# UNITED STATES PATENT AND TRADEMARK OFFICE

APPLICATION NO.	FILING DATE	FIRST NAMED INVENTOR	ATTORNEY DOCKET NO.	CONFIRMATION NO.
10/776,851	02/11/2004	Uwe Jurgen Becker	CM2687MQ	3886

<b>Office Action Summary</b>	<b>Application No.</b> 10/776,851	<b>Applicant(s)</b> BECKER ET AL.	
	<b>Examiner</b> Ginger T. Chapman	<b>Art Unit</b> 3761

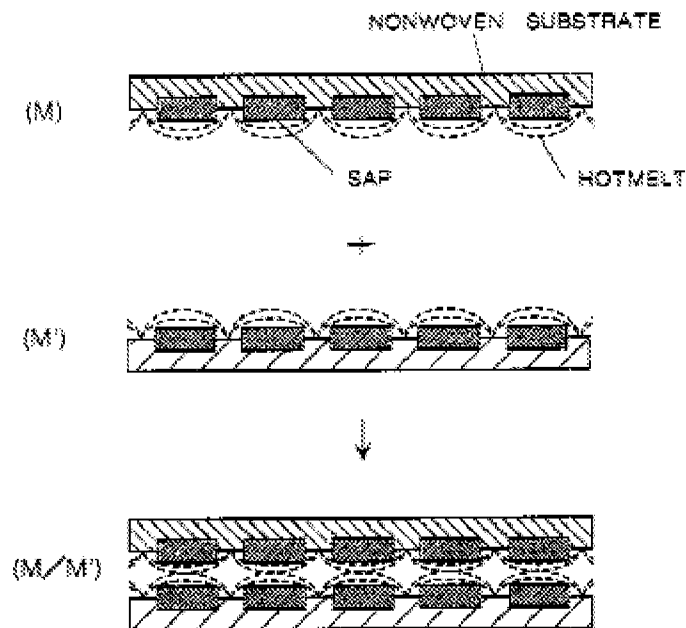
first and second substrate layers (M)(M') each having absorbent material (SAP) deposited on said first and second substrate layers;

and a thermoplastic material (hotmelt), wherein said thermoplastic material (hotmelt) contacts at least portions of the absorbent material (SAP) and at least portions of said first and second substrate layers (M)(M') such that the absorbent material (SAP) is immobilized on said first and second substrate layers (M)(M'),

wherein said first and second substrate layers (M)(M') are combined together such that said thermoplastic material (hotmelt) of each of said first and second substrate layers (M)(M') contact one another;

said absorbent material (SAP) comprises an absorbent polymer material and a absorbent fibrous material, wherein said absorbent material (SAP) is immobilized (trapped in pockets in hotmelt/substrate layers) when wet such that said absorbent core (M/M') achieves a wet immobilization (liquid is immobilized in the pockets by the superabsorbent (SAP and pocket structure)(see fig. 17, infra).

Regarding claim 3, Suzuki teaches that the thermoplastic material includes a hot melt adhesive (see fig 17, *supra*).

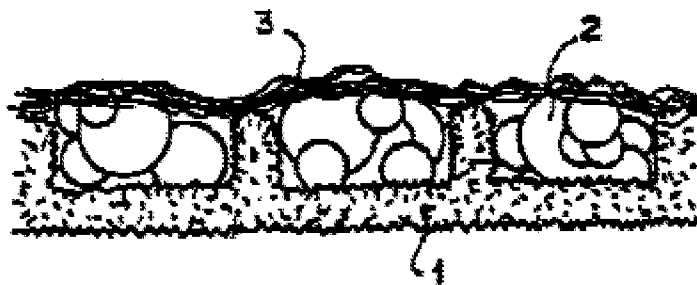
Regarding claim 6, Tanzer teaches an absorbent core (12, 42, 50, 58) having a distribution of absorbent polymer material wherein the distribution of absorbent polymer material is profiled (polymer (58) distribution changes along longitudinal length of sheet (12))(see fig. 3, *supra*).
